Mr. Andrew McAllister
Commissioner
California Energy Commission
Dockets Office, MS-4
Re: Docket No. 14-BTSD-01
1516 Ninth Street
Sacramento, CA 95814-5512

**Philips Lighting Comments on Staff
Workshop on Proposed Lighting
Efficiency Measures for Residential and
Nonresidential Buildings**

Date: 2014-06-25

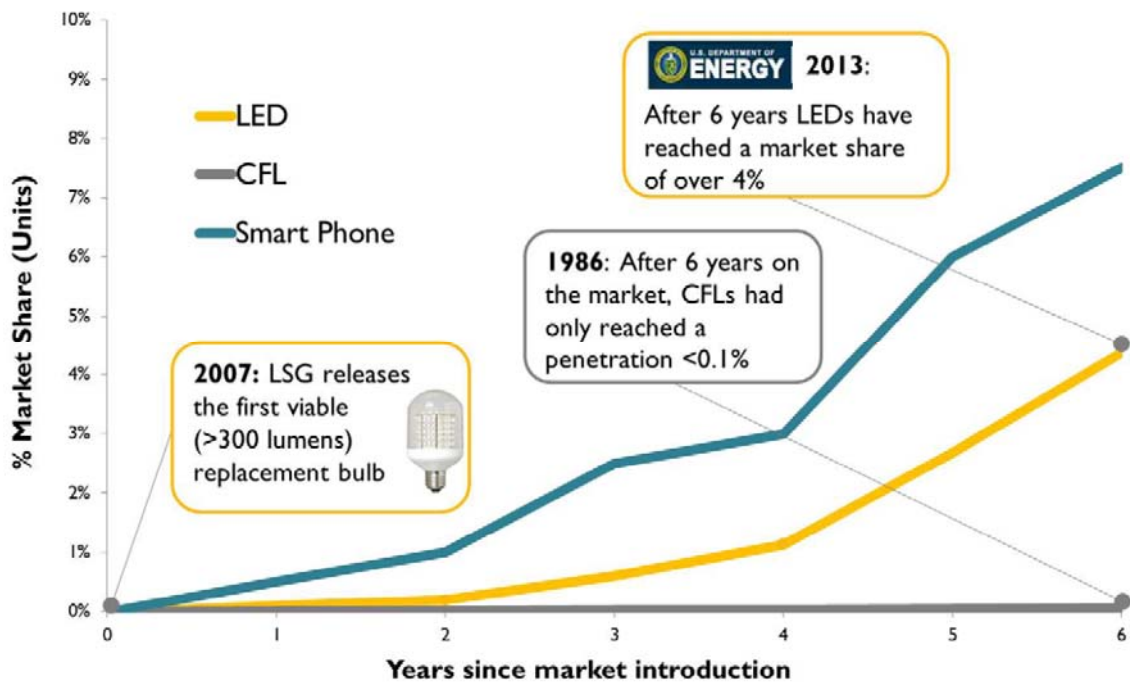
Now, just to show that comparing LEDs to CFLs may not be appropriate, a chart was given in the presentation that showed what happened to the market penetration of CFLs over time and the corresponding price. It would lead one to believe that price alone may not drive penetration and that may have been true for CFLs due to all the other problems associated with CFLs such as color quality, startup time, dimmability, etc. But this is far from the case for LEDs as demonstrated in the following chart:

Although CFLs have come a long way over the years and the Energy Star approved products do not exhibit many of the problems cited, consumers have a long memory and still associate these problems with CFLs. Fortunately, LEDs don't have that bad rap and the DOE has strived to make sure it doesn't happen through such efforts as the Lighting Facts Label, CALiPER and Gateway. Even so, unless California or nationally, a minimum standard is adopted, there is nothing to prevent low performing LED products from entering the market and developing a poor image for LED products. NEMA developed SSL-4 as a potential minimum standard to address this situation and it has been adopted by Mexico and Canada.
